Serial: RNP-RA/01-0164

H. B. ROBINSON STEAM ELECTRIC PLANT, UNIT NO. 2
DOCKET NO. 50-261/LICENSE NO. DPR-23

REQUEST FOR TECHNICAL SPECIFICATION CHANGE TO
ELIMINATE REQUIREMENTS FOR THE POST-ACCIDENT SAMPLING SYSTEM

5.5.3

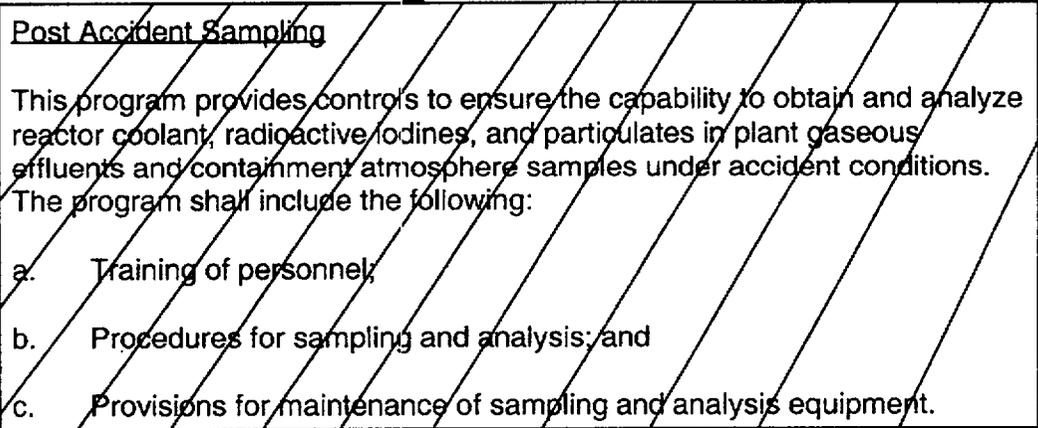
DELETED

Post Accident Sampling

This program provides controls to ensure the capability to obtain and analyze reactor coolant, radioactive iodines, and particulates in plant gaseous effluents and containment atmosphere samples under accident conditions. The program shall include the following:

- a. Training of personnel;
- b. Procedures for sampling and analysis; and
- c. Provisions for maintenance of sampling and analysis equipment.

5.5.3 DELETED
